SUBDIVISION COMMITTEE  
METROPOLITAN AREA PLANNING COMMISSION

STAFF REPORT  
(Preliminary Plat)

CASE NUMBER: S/D 90-10 - SMITHMOOR THIRD ADDITION

Re: S/D 90-10 (Final Plat) Smithmoor 3rd Addition

VICINITY MAP:

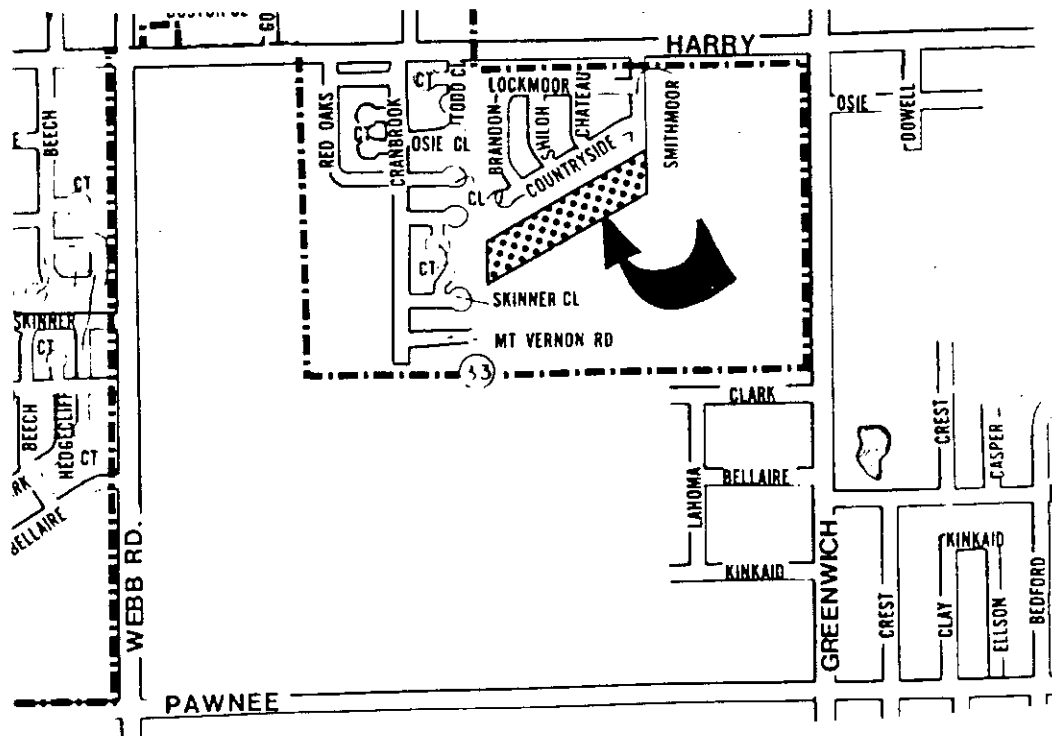
- A. The applicant shall guarantee the extension of sanitary sewer to serve the lots being platted.
- B. The applicant shall guarantee the extension of City water to serve the lots being platted.

- C. The applicant shall guarantee any drainage improvements required by the platting of this property.
- D. The applicant shall guarantee the paving of the proposed interior streets. This guarantee shall also include the paving of Smithmoor adjacent to the east line of this plat, including a sidewalk along the west side of this street, and the installation of temporary culs-de-sac for termination of the four interior streets. Since the property to the south of this site is in the same ownership as the area being platted, these culs-de-sac should be dedicated off-site. This dedication can either be provided by the plat or by separate instrument, with the vacation of each temporary cul-de-sac being effective upon the extension of a street southward.

- F. The final plat shall indicate Bluestem/Honeytree with a 64-foot right-of-way. The number of lots potentially accessing this street and its alignment suggest this street will require a 64-foot right-of-way.

- G. The applicant shall submit a covenant which provides for four (4) off-street parking spaces per dwelling unit on each lot which abuts a 29-foot street. The covenant shall inventory the affected lots by lot and block number and shall state that the covenant runs with the land and is binding on future owners and assigns.

- I. The applicant shall submit a copy of the instrument which establishes the pipeline easement on this property. The applicant's agent shall determine any setback requirements from the pipeline by researching the text of the pipeline agreement. The name of the pipeline company and the recording information for the easement shall be indicated on the face of the plat.

- J. Any relocation, lowering or encasement of the pipeline, made necessary by this development, will not be at the expense of the City.
- K. The final plat shall reference a tie point to a previously plat-  
ted lot corner or section corner.

- L. If required, the final plat shall indicate minimum building pad  
elevations in both Mean Sea Level and City Datum. A table shall  
indicate any involved lots and the plat-  
tor's text shall also  
reference the minimum pads. It should also be indicated if the  
minimum elevations involve the lowest level or opening. On-site  
and off-site benchmarks shall also be shown on the face of the  
plat.

- M. On the final plat, the 20-foot utility easements on Blocks 2, 3,  
and 4 shall be clearly indicated as being centered on the lot  
lines by also indicating that the lot lines are the center line  
of the easements, e.g. "CL 20' - Utility Easement."

- N. Prior to or at the time of submitting the final plat, the appli-  
cant shall submit a drainage plan to City Engineering for review  
and approval. This drainage plan shall take into account off  
site drainage, that flows through this site, as is shown on the  
sketch plat for the overall area of development.

VICINITY MAP:

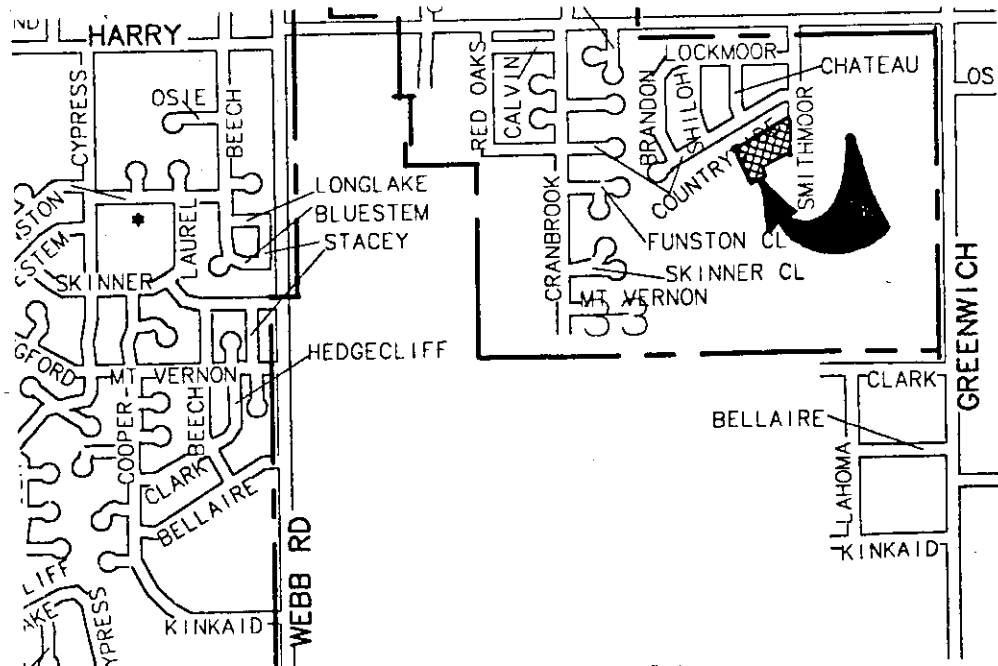
- A. The applicant shall guarantee the extension of sanitary sewer to serve the lots being platted.
- B. The applicant shall guarantee the extension of City water to serve the lots being platted.

- C. The applicant shall guarantee any drainage improvements required by the platting of this property. This guarantee may be included with the street paving guarantee.

- D. The applicant shall guarantee the paving of the proposed interior streets. This guarantee shall also include the paving of Smithmoor adjacent to the east line of this plat, including a sidewalk along the west side of this street, and the installation of temporary culs-de-sac for termination of the interior streets (Bluestem & Chateau). Since the property to the south and west of this site is in the same ownership as the area being platted, these culs-de-sac should be dedicated off-site. This dedication can either be provided by the plat or by separate instrument, with the vacation of each temporary cul-de-sac being effective upon the extension of a street southward and/or westward.

- F. On the final plat tracing, the name of the Addition shall be indicated.
- G. The applicant shall submit a covenant which provides for four (4) off-street parking spaces per dwelling unit on each lot which abuts a 58-foot street. The covenant shall inventory the affected lots by lot and block number and shall state that the covenant runs with the land and is binding on future owners and assigns.

- H. The applicant shall submit a copy of the instrument which establishes the pipeline easement on this property. The applicant's agent shall determine any setback requirements from the pipeline by researching the text of the pipeline agreement.

- I. Any relocation, lowering or encasement of the pipeline, made necessary by this development, will not be at the expense of the City.
- J. Since the pipeline crossing this site is a private easement, the reference to this easement should be deleted from the platting text.

- K. The final plat shall reference a tie point to a previously plat-  
ted lot corner or section corner.
- L. If required, the final plat tracing shall indicate minimum build-  
ing pad elevations in both Mean Sea Level and City Datum. A  
table shall indicate any involved lots and the plat-  
tor's text shall also reference the minimum pads. It should also be indi-  
cated if the minimum elevations involve the lowest level or open-  
ing. On-site and off-site benchmarks shall also be shown on the  
face of the plat.

- M. If the easement between lots 1 and 2, Block B is for sanitary  
sewer, a 20 foot easement shall be shown on the final plat trac-  
ing.
- N. The MAPC signature block shall be amended to indicate George  
Sherman, "Chairman."
